TECHNICAL INFORMATION

TI0621

HO Siamonie Smart

Preparation for Siamonie Smart fresh milk module

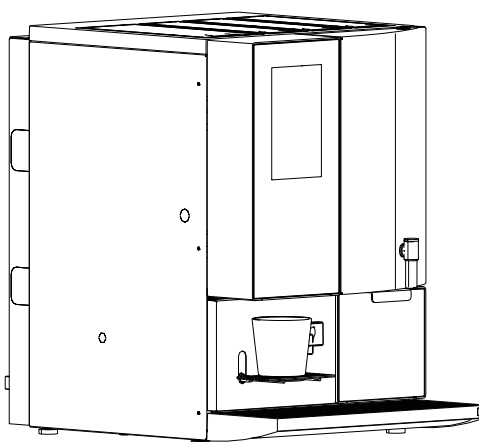
The external fresh milk module can be attached to a prepared Siamonie Smart very quickly. Coated perforations are integrated into the left side wall and into the rear wall of the Siamonie Smart for this purpose. These perforations are barely visible and can be broken out, if needed. The cable tree has also been upgraded with the necessary wires.

The preparation will be included as standard from serial number 90523292 and production date CW13/2021. Appliances prior to the production date of CW13/2021 cannot be overhauled or retrofitted.
